Commission Agenda Report

Planning Commission Meeting
02-17-26
Item 5.A.

Subject: Coastal Development Permit No. 23-034 and Minor Modification No. 25-009 – An application for the construction of a new single-family residence and accessory development

Location: 33008 Pacific Coast Highway, within the appealable coastal zone
APN: 4473-017-009
Owner: Bluff Top 1 LLC

Figure 1 – Shared Easement Illustration

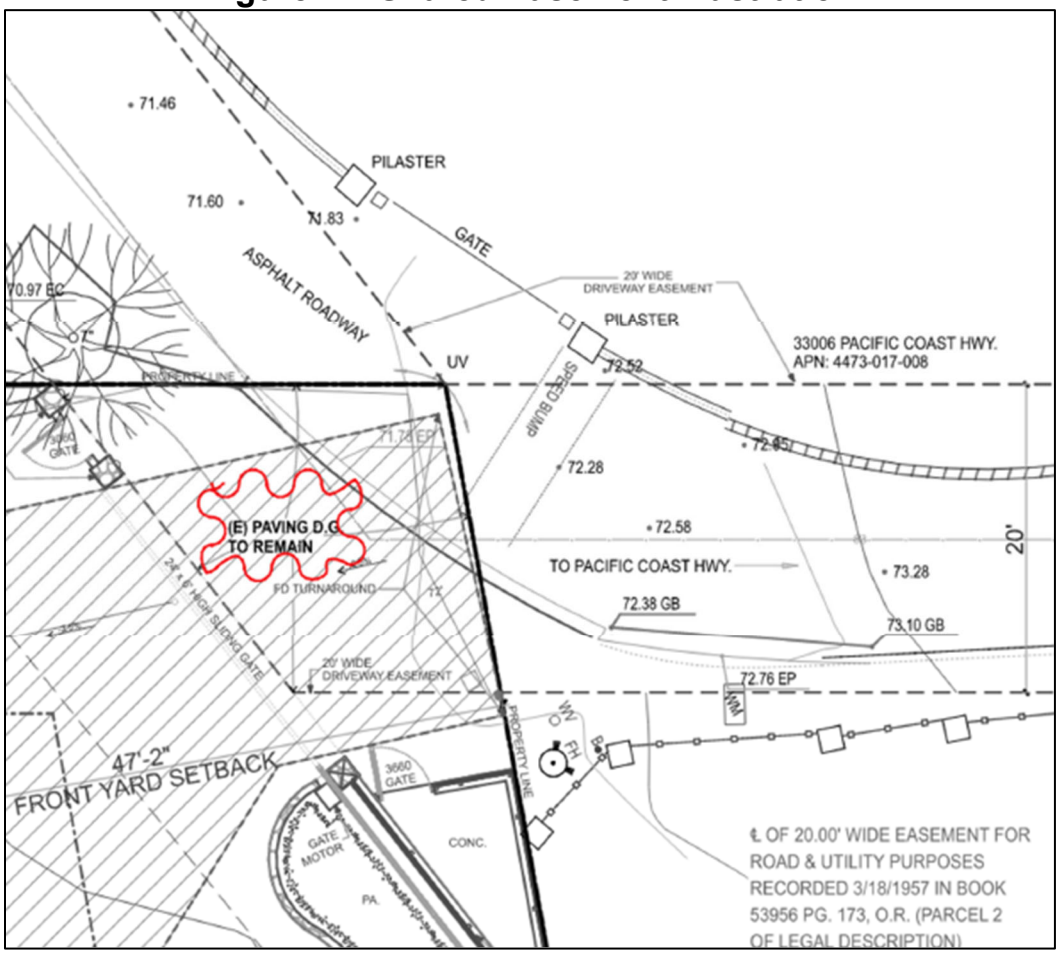
Comment 2 – Co-Applicant, LIP § 13.6.2(C): No such invitation has been extended to the adjacent neighbor who has a shared easement over the property, including over areas proposed for development.

Staff Response: The subject project does not propose any development within the shared private access easement with other properties. Revised plans have been submitted to further clarify that no development will be proposed within the portion of the shared easement. See partial screen shot below (Figure 1) of the area within the easement which will remain as is. The prior version of the plans erroneously stated that the area was existing pavement to remain but confirmed to be existing decomposed granite (DG) to remain.

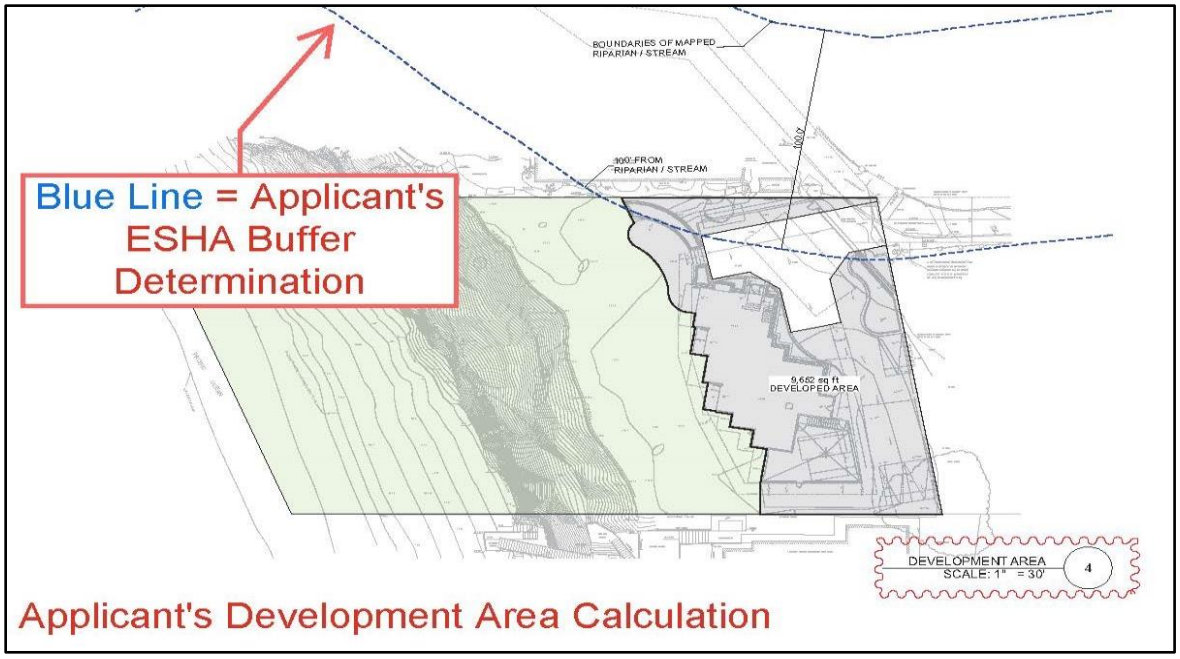
As shown on the Project Plans, the Project lies partially within an ESHA buffer. (See, e.g., Plan Sheet A-0.2, showing new planters, gates, walls, pilasters, and fencing located behind a line labeled "approx. 100' from ESHA boundary.") Our Clients' biologist team, Amigo Environmental, LLC ("Amigo"), prepared a peer-review of the Applicant's biological assessment (the "Amigo Report"), attached as **Exhibit A**, which likewise states that "at least a portion of the subject property and proposed Project may be located within an ESHA buffer and/or within 100 feet of protected of riparian habitat." (*Id.* at 4.) Accordingly, the Project must comply with the development-area limitations that apply to such projects. Indeed, Applicant admits as much by purporting to demonstrate compliance with the development area limitation on Sheet A-0.3 of the Plans. (See Sheet A-0.3, below, marked-up.)

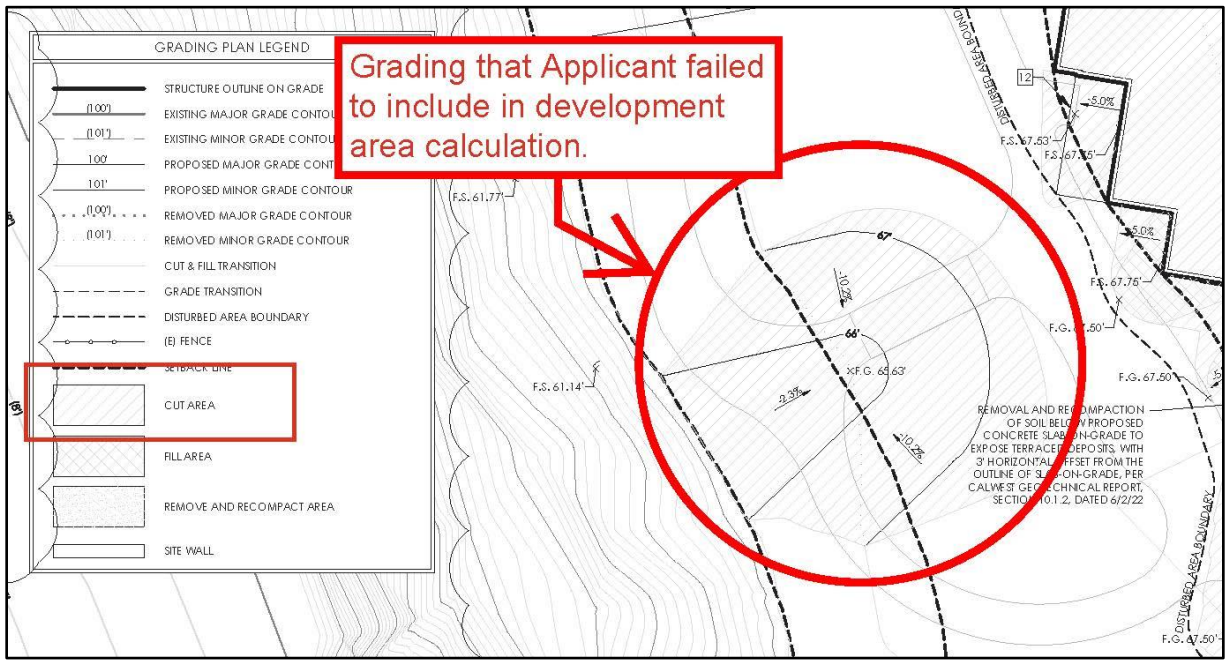
2. Applicant incorrectly excluded significant portions of the Property from development. For example, a large, circular area of grading is proposed near the coastal bluff, apparently to provide a catch basin for drainage:

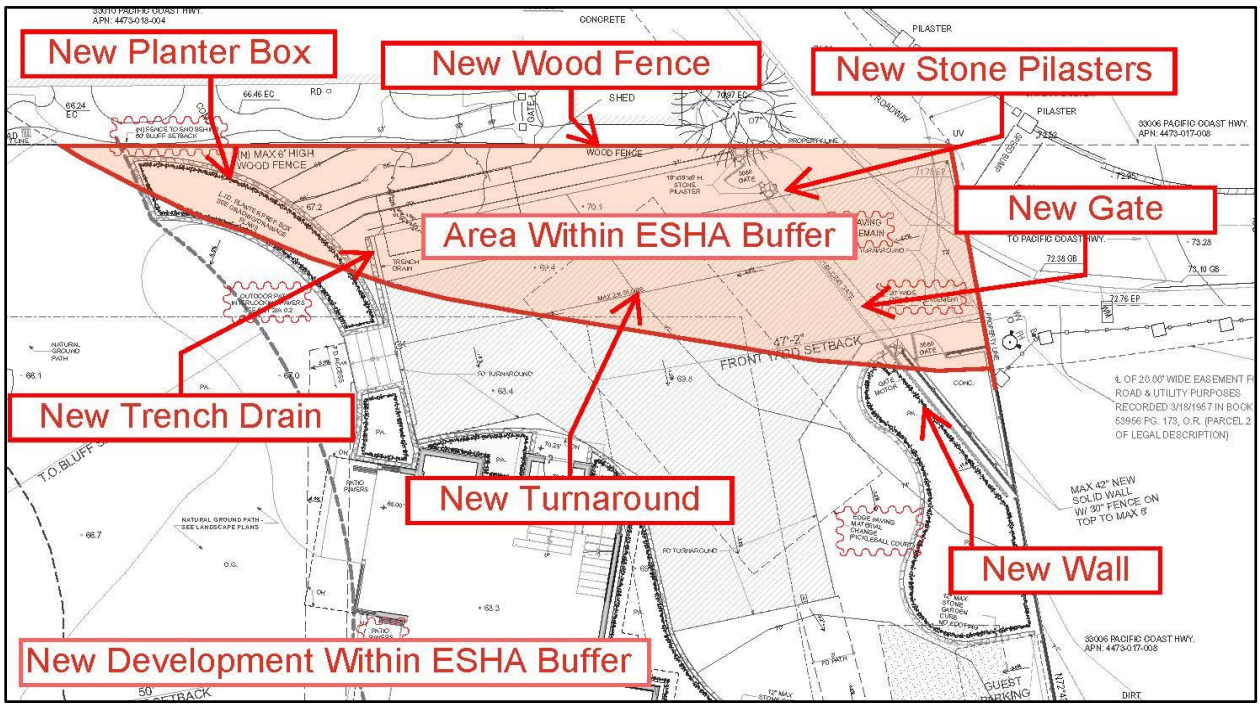
and driveway, planter boxes, and landscaping. A marked-up Sheet A-0.3 (Site Plan), below, shows this issue:

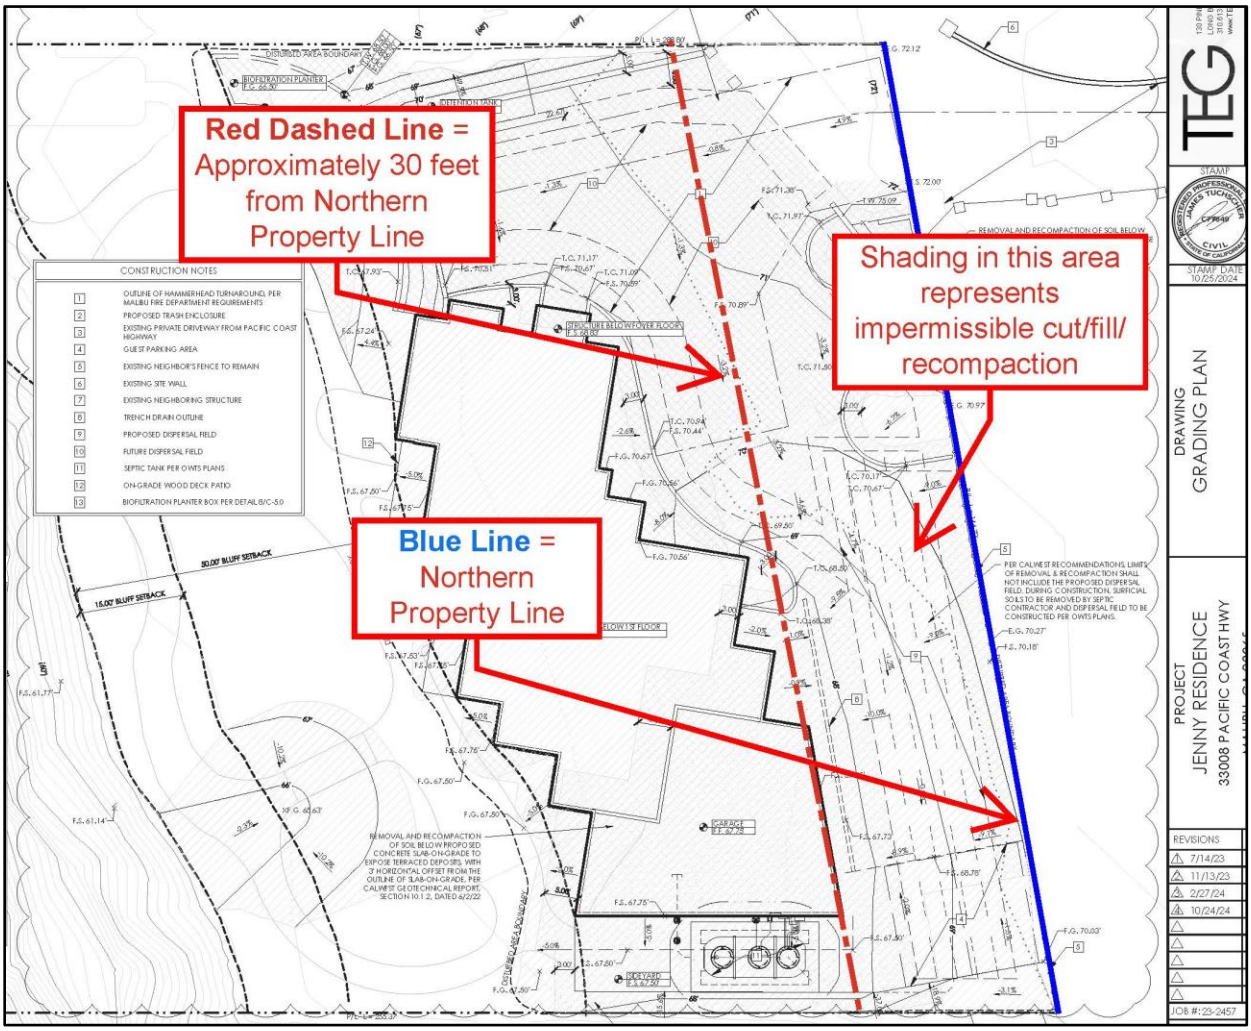
Here, the Project patently violates this requirement by proposing significant grading along the entire northern property boundary, as shown on Sheet C-3.0 of the civil engineering plans. (Note: north is on the right side of the sheet.)

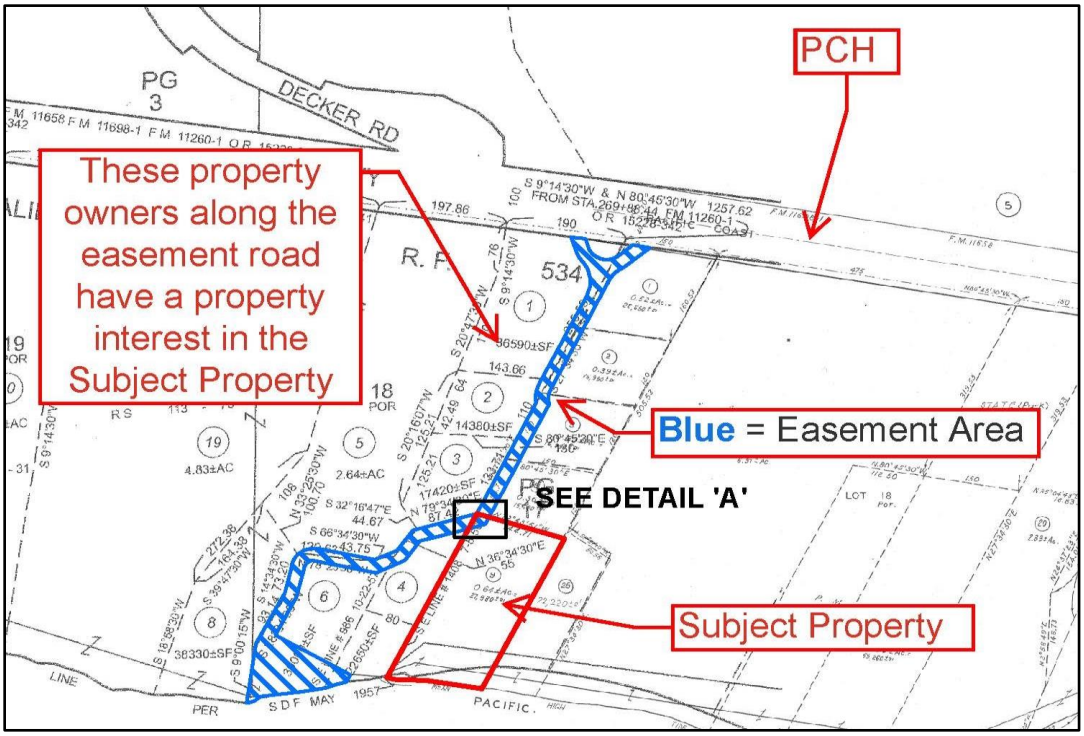
To our Client's knowledge, **no easement holders were ever invited to join the application as co-applicant**. Further, no such invitation is included in the materials before this Planning Commission. Because the City and Applicant failed to invite interest holders to join as co-applicants, the application was, at best, incomplete and cannot be acted upon now. (LIP § 13.6.2.) See below depiction.

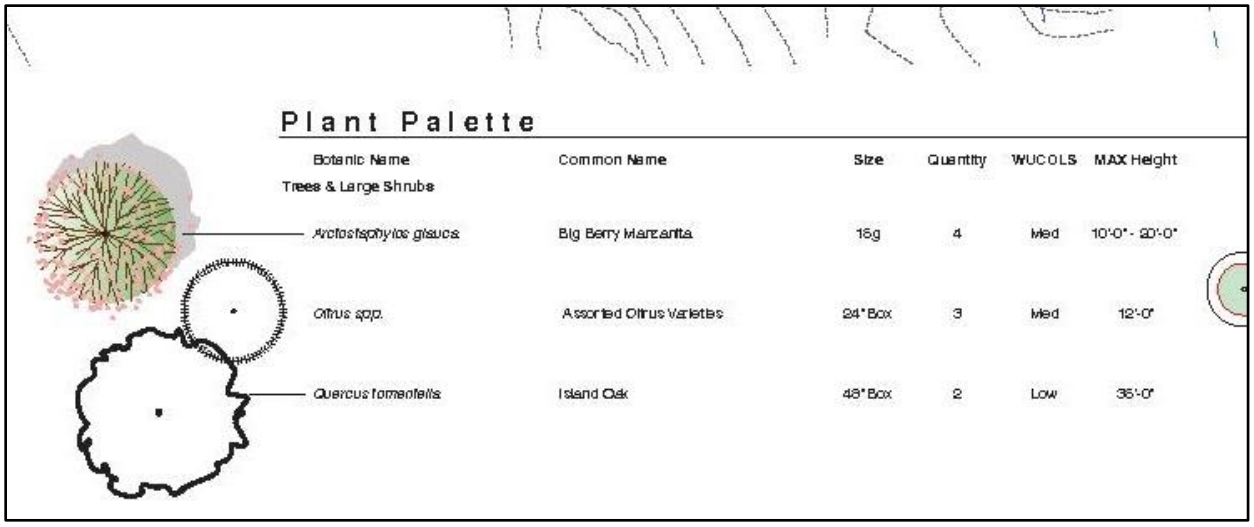
Nevertheless, the Project's landscape plans include trees that appear destined to violate the PVD and the Project's conditions of approval. Sheet L3.00 of the landscape plans, for example, notes four proposed Big Berry Manzanita trees with a maximum height of 10 to 20 feet, three proposed citrus trees with a maximum height of 12 feet, and two proposed Island Oak trees with a maximum height of 35 feet. The Applicant proposes to scatter these trees around the Property.

Although staff attempts to address this issue by referencing Condition of Approval No. 33, the current architecture and landscape plan inherently conflicts with that condition and the visual-resource findings required by LIP section 6.6.4. Approval of trees capable of growing five to six times the permitted view height invites a future code-enforcement action once the vegetation matures.

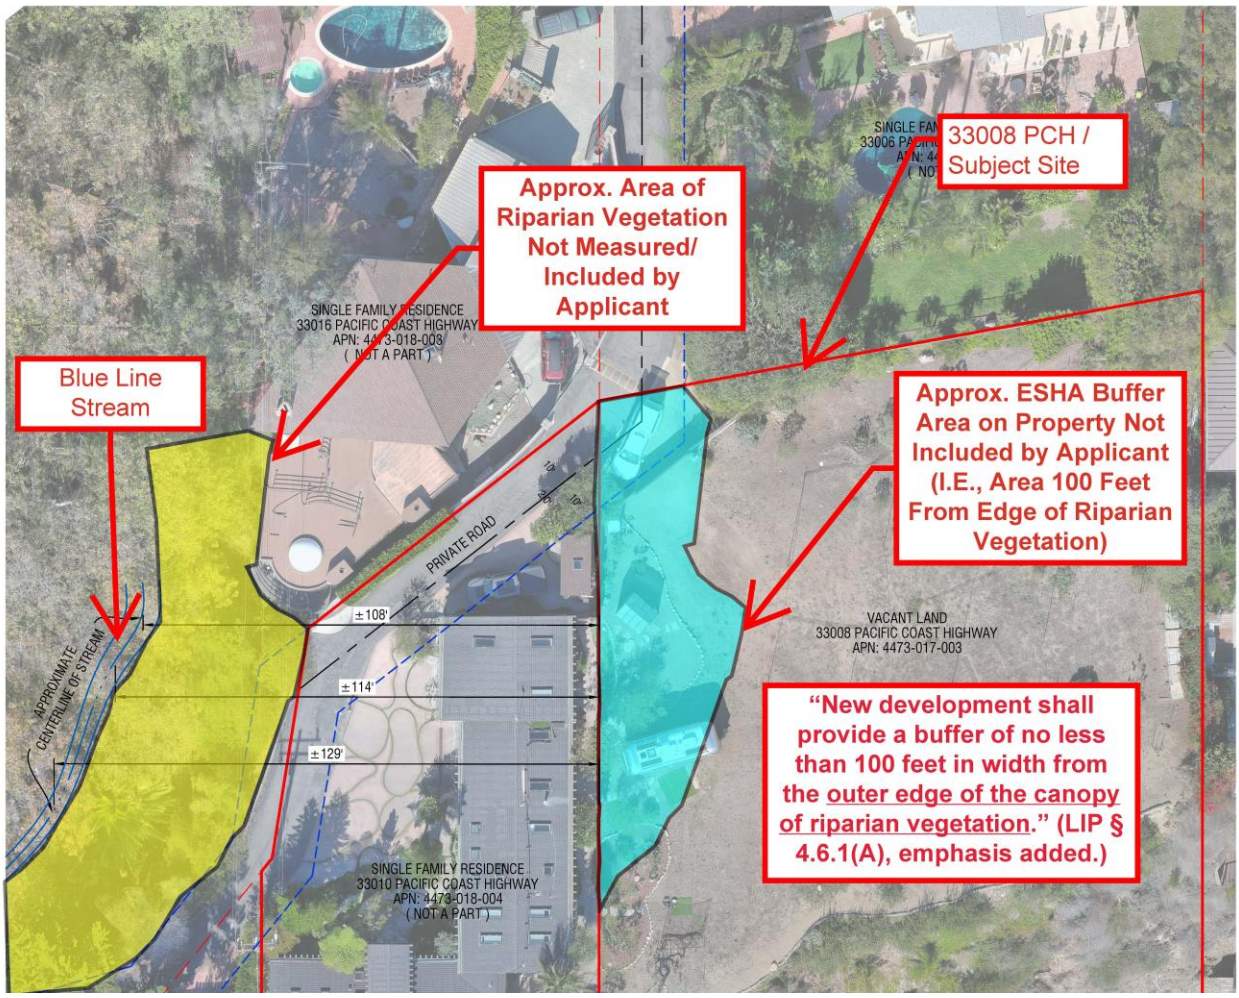
A marked-up version of the Applicant's aerial drone exhibit demonstrates this point:

To reiterate: the Applicant, by its own admission, measured the distance between the Property and the "top of bank." It failed to measure the distance to the outer edge of the riparian vegetation, which extends laterally eastward. (Worse, the biologist's exhibit measures from the centerline of the stream, not the top of bank.) At the same time, even a casual review of the stream from google maps shows vegetation extends outward from the banks of the stream. In fact, Applicant's own biological assessment admits that riparian vegetation extends outward from the stream:
